NUREG-0011  
Supplement No. 3

# **Safety Evaluation Report**

related to the operation of  
Sequoyah Nuclear Plant,  
Units 1 and 2

Docket Nos. 50-327 and 50-328

FIGURE 1

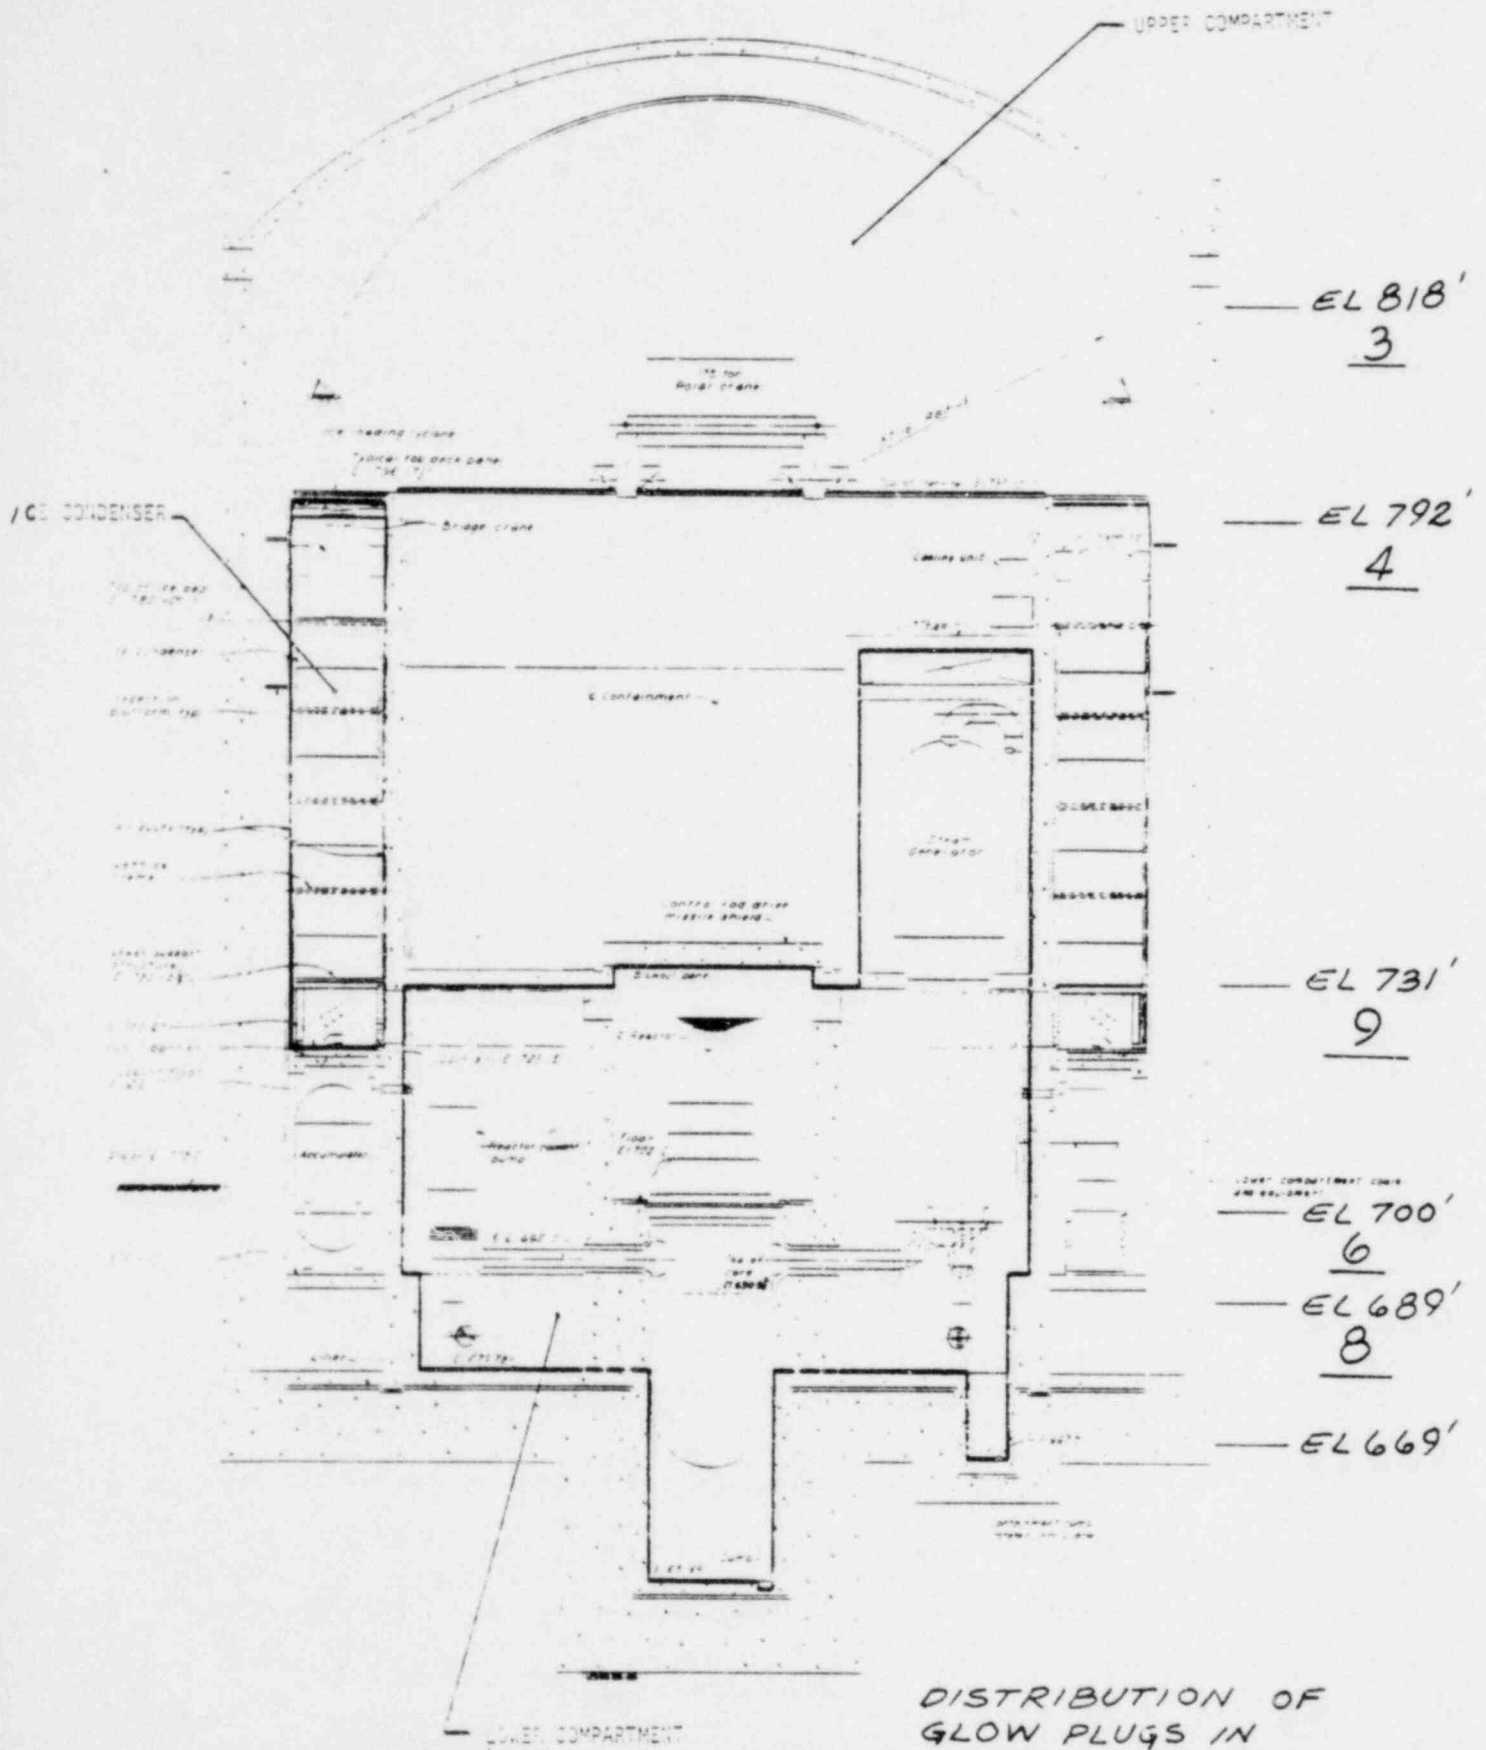
Figure 1 is an elevation view of the Sequoyah containment and indicates the number of glow plugs TVA proposes to locate at various elevations in the containment. TVA proposes to provide a total of 30 glow plugs. Eighteen glow plugs will be located in the lower compartment; 8 at the 689.0' elevation, 6 at the 700.0' elevation and 4 at the 731.0' elevation (in the openings to the steam generator compartments). Five glow plugs will be located in the lower plenum of the ice condenser at the 731.0' elevation, and 4 glow plugs will be located in the upper plenum of the ice condenser at the 792.0' elevation. Three glow plugs will be located in the upper compartment at the 818.0' elevation.

FIGURE 3. CLASIX MODEL OF ICE CONDENSER CONTAINMENT

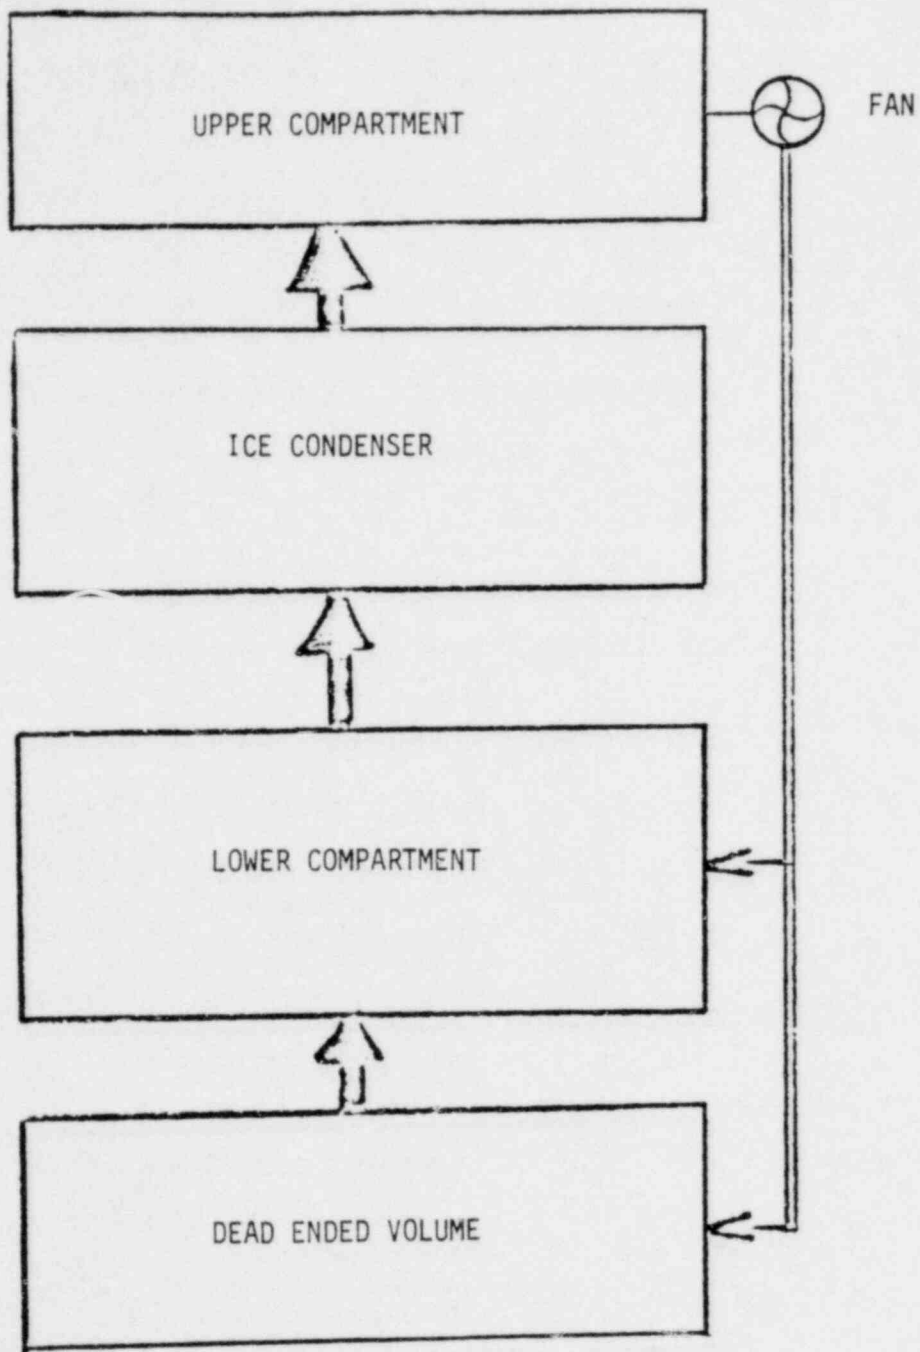
The TVA results using CLASIX are based on an unverified, unreviewed code, which is still under development. This calculational technique, in the staff's opinion does hold considerable promise for estimating the containment transient response due to hydrogen combustion since it already contains many basic features necessary to perform the calculation. Furthermore, the results from CLASIX tends to be confirmed by the results from the MARCH code.

Figure 1. Uniform mixtures in the Sequoyah containment vessel.

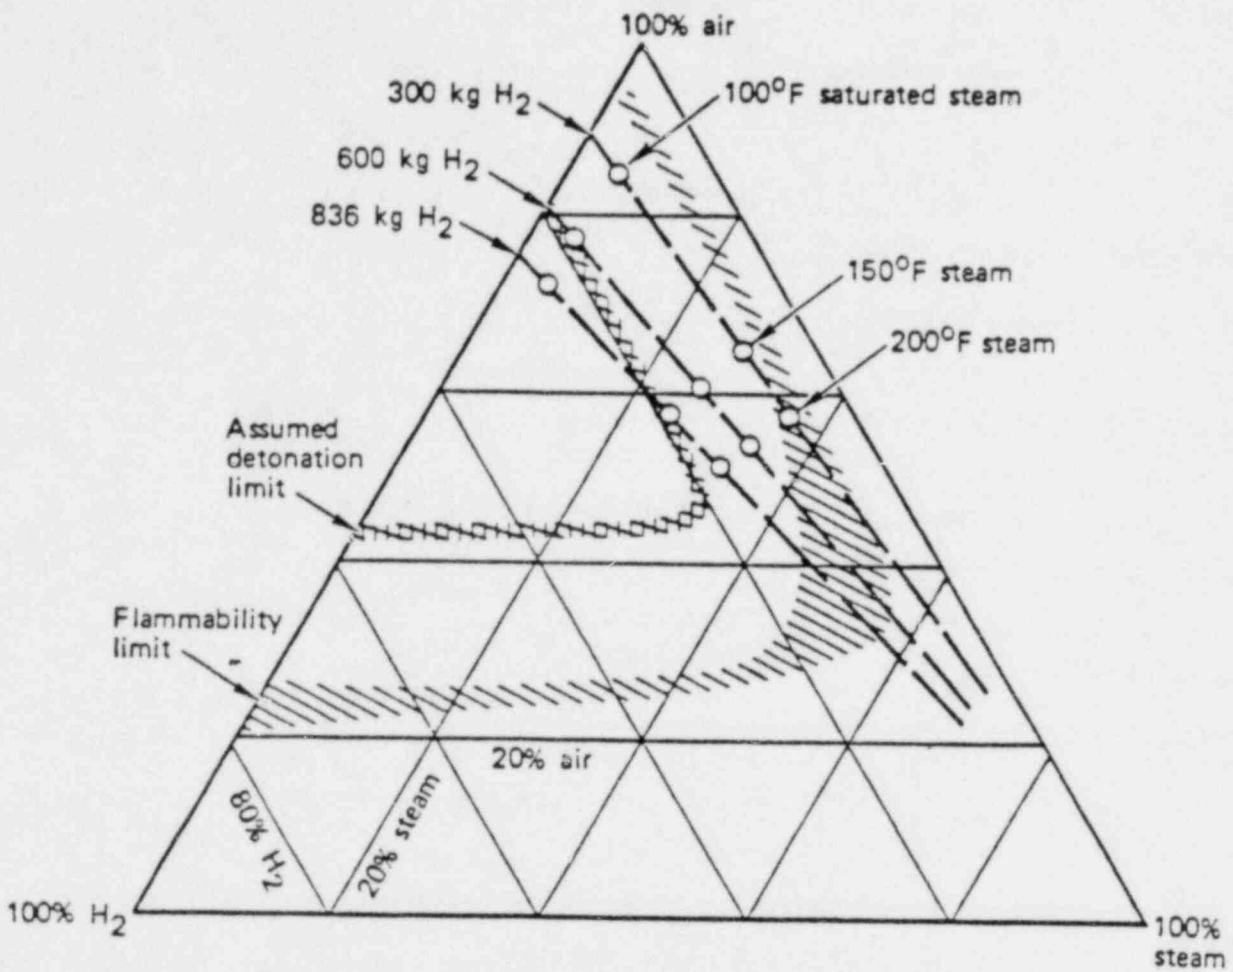
1. a) 300 kg of  $H_2$  gas mixed uniformly with the air and steam (if less than 40 percent steam) in the Sequoyah containment volume following an accident would be completely combustible if ignited (see Figure 1). This complete combustion could occur so rapidly as to exceed the capacity of the available heat removal processes, and could produce a pressure as high as 5.5 atmospheres, thus rupturing the containment (see Table 2). The combustion of 600 kg of  $H_2$  would of course have more severe consequences.

Figure 2. Locus of state points for mixtures of 40,000 cfm air with the hydrogen yield of various Zr reaction rates.

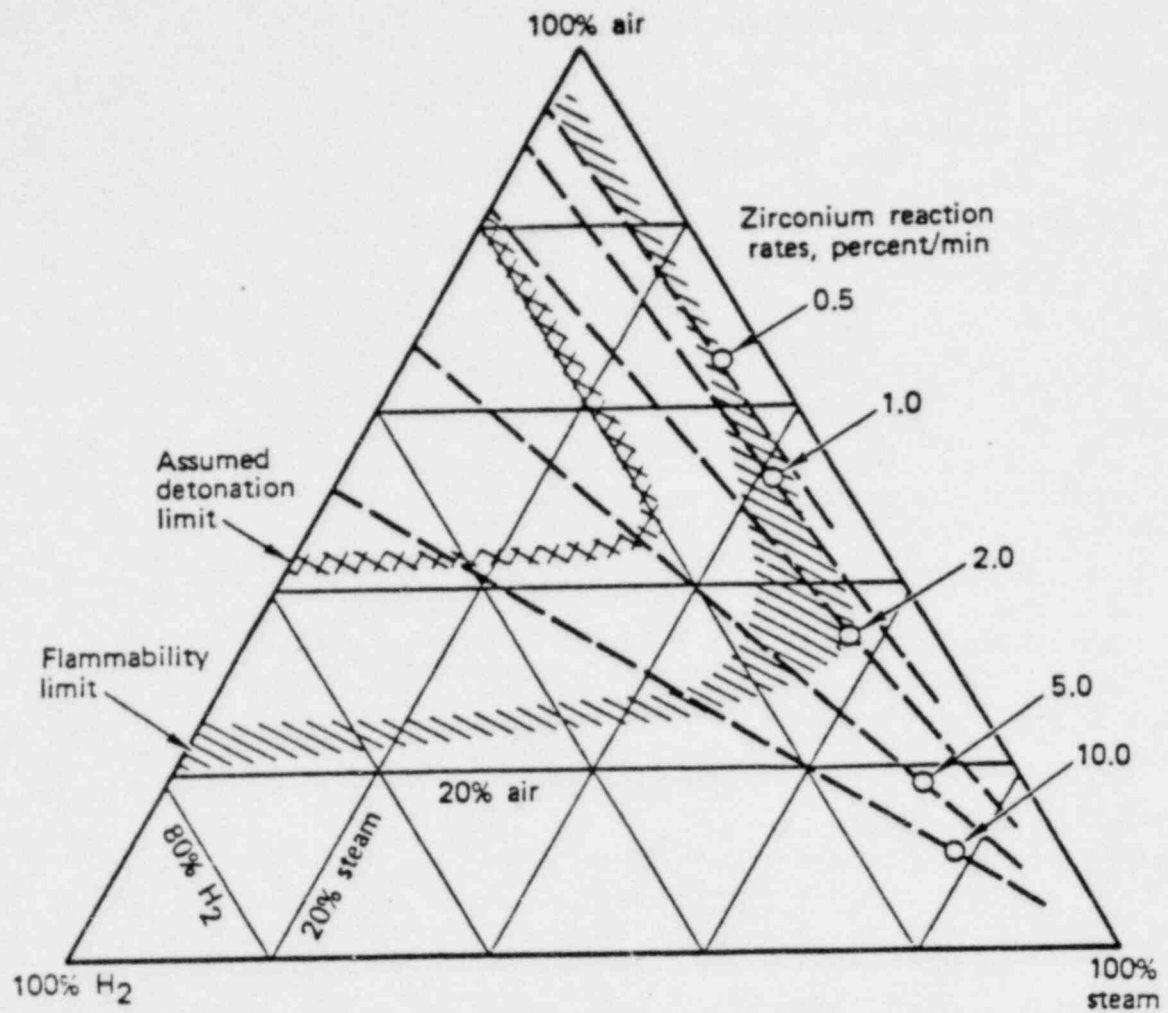
A reference calculation is illustrated in Figure 2, where mixtures of 40,000 cfm air and the hydrogen yields of various rates of zirconium reaction are plotted on the ternary mixture chart. Each reaction rate corresponds to a straight-line locus, with steam rate determining the position on any line. The one point plotted on each line is for a steam rate that corresponds to the heat release rate of the Zr-H<sub>2</sub>O reaction and the latent

heat of vaporization of water. It can be seen in Figure 2 that the yield of Zr-H<sub>2</sub>O reaction rates in excess of 2% per minute can produce detonable mixtures with 40,000 cfm of air if the steam content is sufficiently low. Rates of several percent per minute were calculated for some accident scenarios in WASH 1400.
